Opportunity to reappraise the New Monks Farm development

Sussex Pad Crossing

Sussex Pad alternative path widths (along River Adur) compared to minimum standards

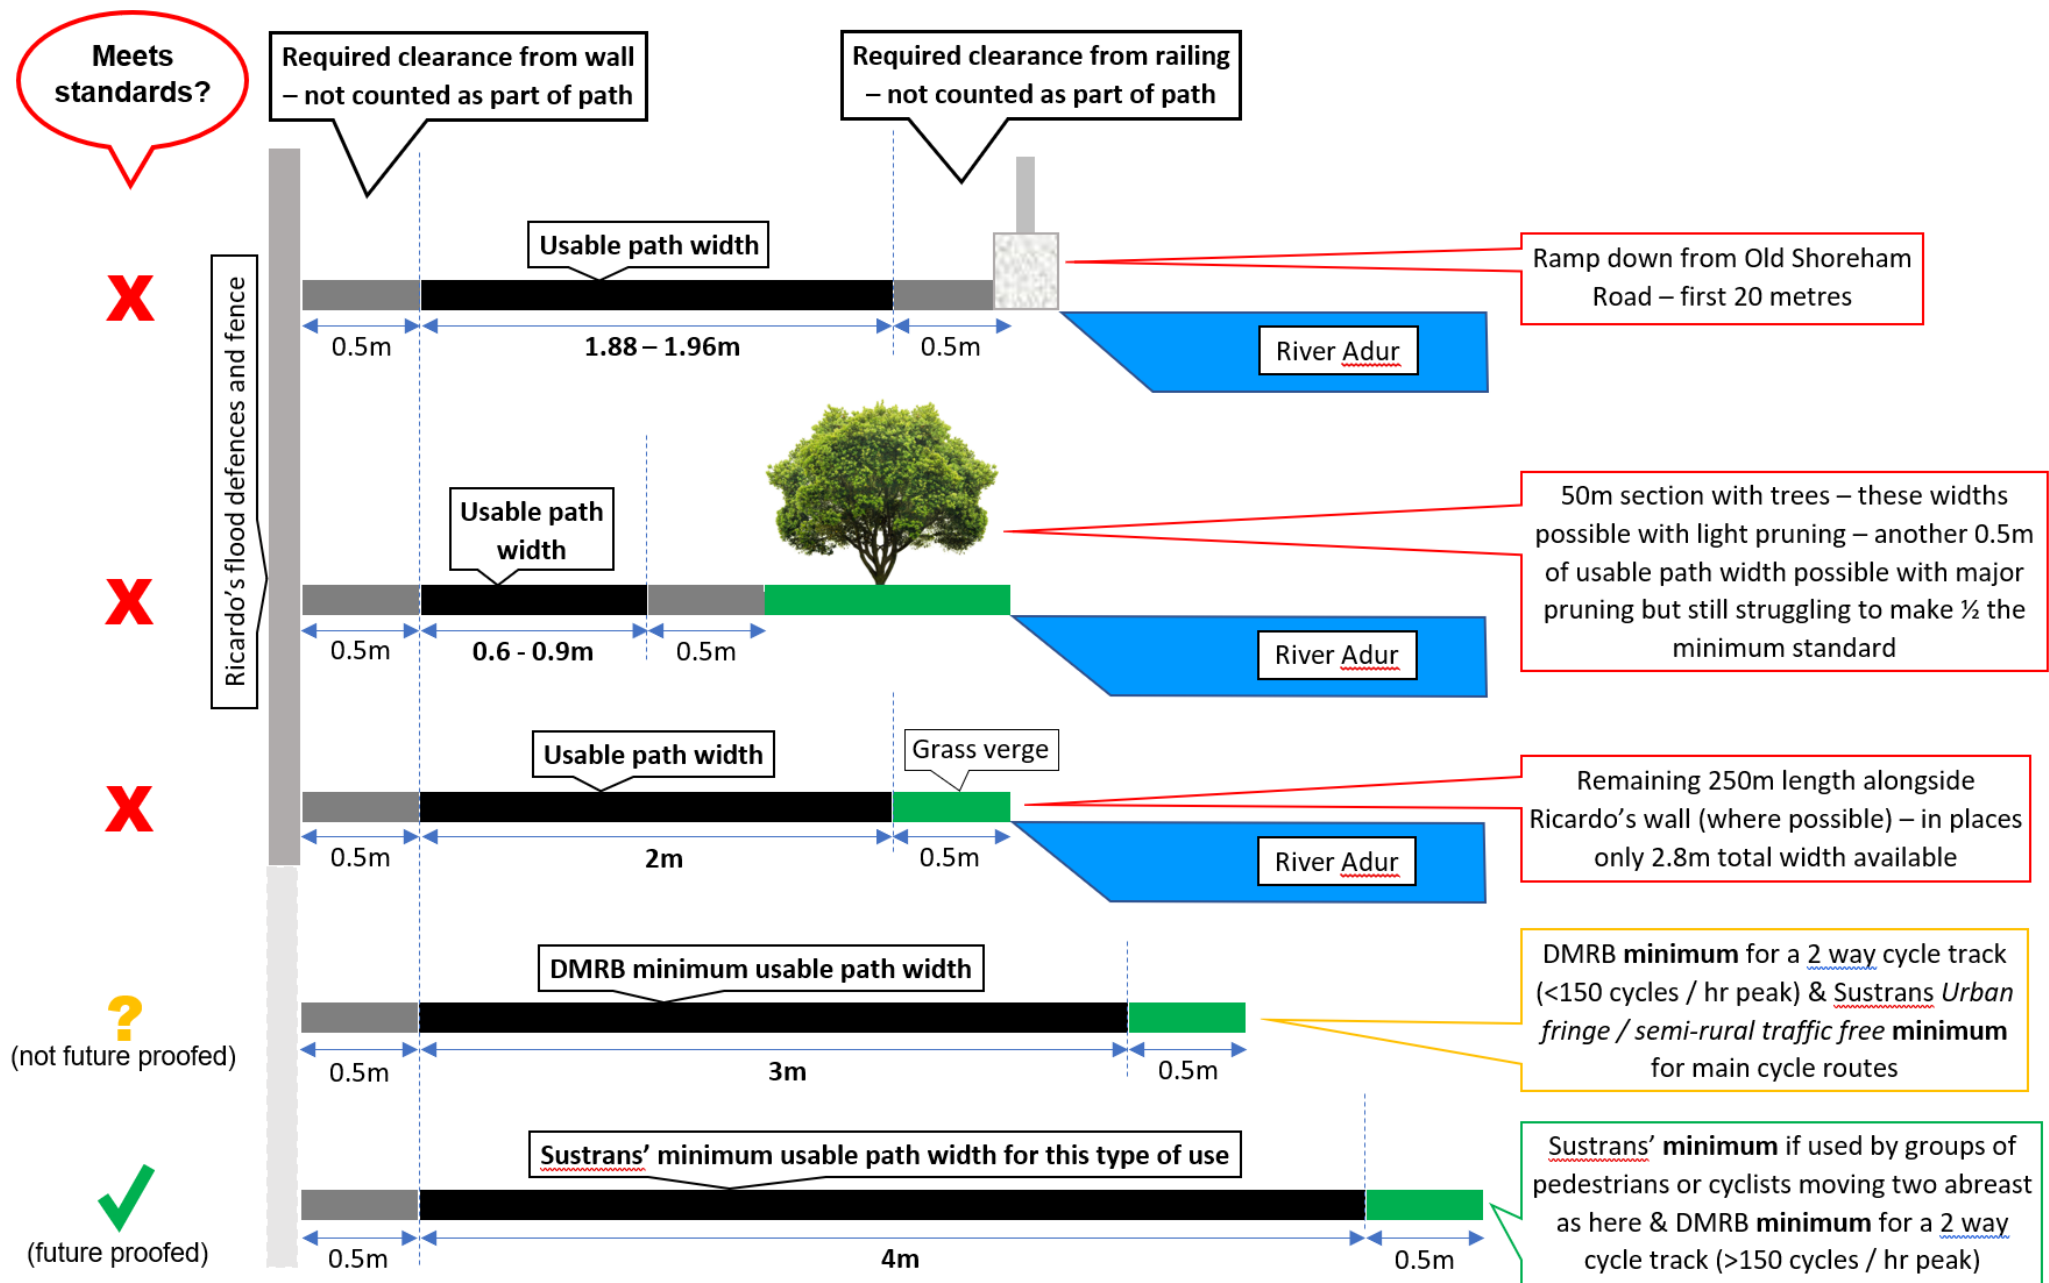
1. The path will be 2.5 metres along its whole length
2. The path has a usable width of 3.5 metres along its whole length, apart from a short section adjacent to Ricardo's where its only 2.5 metres wide
3. Cycle counts at the Sussex Pad crossing (they did none themselves on a Sunday) show low usage
4. These widths meet all necessary standards - Sustrans' standards require a 2 metre path, as does the Design Manual for Roads and Bridges (DMRB).

Unfortunately, none of the above are true, apart from possibly the first one and even then that is misleading as it doesn't represent the usable path width, which is only 2 metres or less. This is best shown by the accompanying diagram (see Appendix 3) which illustrates the varying usable path widths against the two standards being quoted, including any mandatory clearances from walls and other obstacles which the developers have failed to take account of when making their claims.

In addition, in relation to point 2, having done a crude survey, measuring the width of the top of the bank in seven places spread out along the path, it is clear that the width available is mostly less than

3.5m and for a number of sections it is under 3 metres, down to as low as 2.8 metres. This demonstrates that with the required clearance from the wall and a safety buffer to the edge of the river, this path can never be wide enough to meet the necessary standards, unless there is a severe incursion into the River Adur and the Site of Special Scientific Interest, or a bridge / pontoon structure is built above the existing path and river.

When the peak hour rate is above 150 cycles an hour, then Table 2.2.11 states that a 4 metre minimum width is required. Therefore, to allow for further growth in cycle use in line with the Government's ambition to double cycling by 2025, the path should be built to accommodate 214 cycle per hour (peak use). This means that a 4 metre path (usable width) should be used as a replacement for the Sussex Pad crossing.
